APPROVAL <i>Slw</i>	REQUEST FOR COUNCIL ACTION	MEETING DATE 08/07/18
REPORTS & RECOMMENDATIONS	RESOLUTION IMPOSING CONDITIONS AND RESTRICTIONS FOR THE APPROVAL OF A SPECIAL USE FOR PROPERTY LOCATED AT 2875 WEST RYAN ROAD TO ALLOW FOR DEMOLITION OF THE EXISTING HALQUIST STONE OFFICE/SHOWROOM AND CONSTRUCTION OF AN APPROXIMATELY 4,207 SQUARE FOOT REPLACEMENT OFFICE/SHOWROOM AND TO ALLOW FOR CHANGES TO THE OUTDOOR LANDSCAPING SHOWROOM AND OFF-STREET PARKING (HALQUIST STONE COMPANY, INC., APPLICANT)	ITEM NUMBER <i>G. 11.</i>

**CITY OF FRANKLIN****REPORT TO THE PLAN COMMISSION**

Special Use Amendment

Project Name:	Halquist Stone Company, Inc. Special Use Amendment
Project Address:	2875 West Ryan Road
Applicant:	Halquist Stone Company, Inc.
Owners (property):	Halquist Brothers Real Estate Partnership
Current Zoning:	B-4 South 27 th Street Mixed Use Commercial District and South 27 th Street Design Overlay District
2025 Comprehensive Master Plan	Mixed Use and Areas of Natural Resource Features
Use of Surrounding Properties:	Commercial (to the north, south and east), Single-Family Residence District (to the west).
Applicant Action Requested:	Request to table the item to the July 19 th P

NEW SOUTH ELEVATION
SCALE 1/4" = 10'

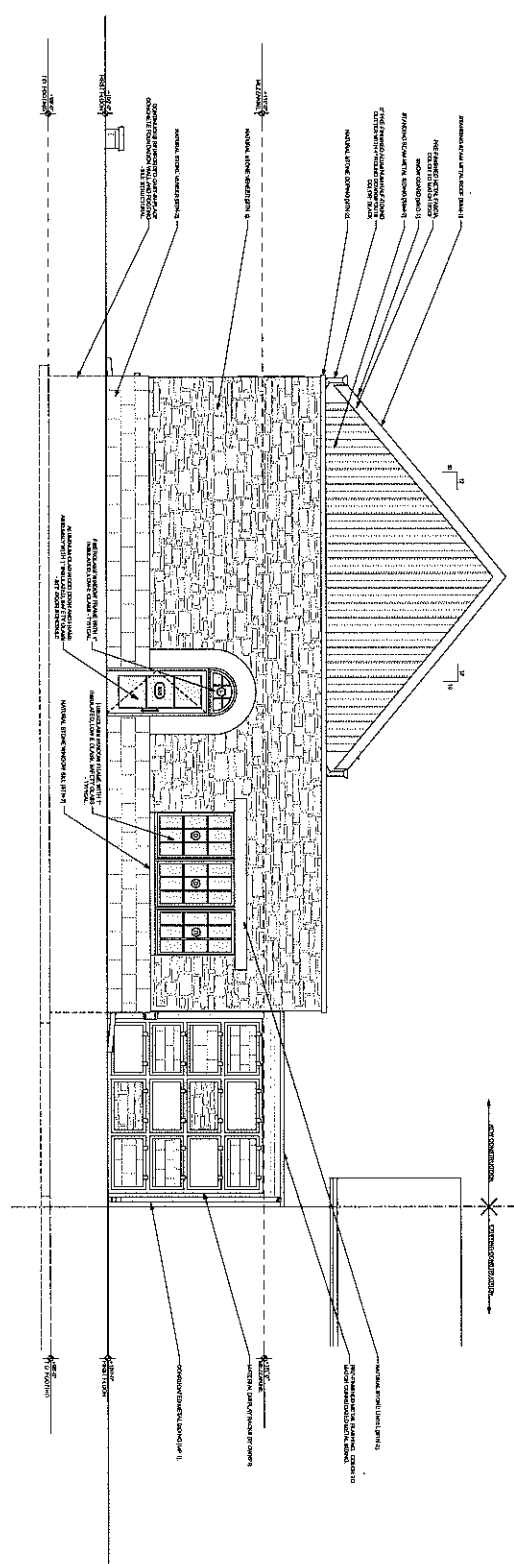
Staff's Recommendation/Suggestion: Staff recommends adding a porch, awning or portico above the main entrance, which compliments the building's exterior.

Staff's Recommendation/Suggestion: Staff recommends using wood siding, cementitious siding (e.g. JamesHardie) or engineered wood siding (e.g. LP SmartSide) in place of corrugated metal siding on the west and south elevations of the building, the gables, and along the roofline.

7. Approval of the requested waiver for Section 15-3.0353B.7. (Pedestrian Considerations), provided the applicant adds a porch, awning, or portico above the main entrance, which compliments the building's exterior.
8. Approval of the requested waiver from Section 15-3.0355B.3.b. (Building Materials and Colors), provided the applicant use wood siding, cementitious siding (e.g. JamesHardie) or engineered wood siding (e.g. LP SmartSide) in place of corrugated metal siding on the west and south elevations of the building, the gables, and along the roofline.
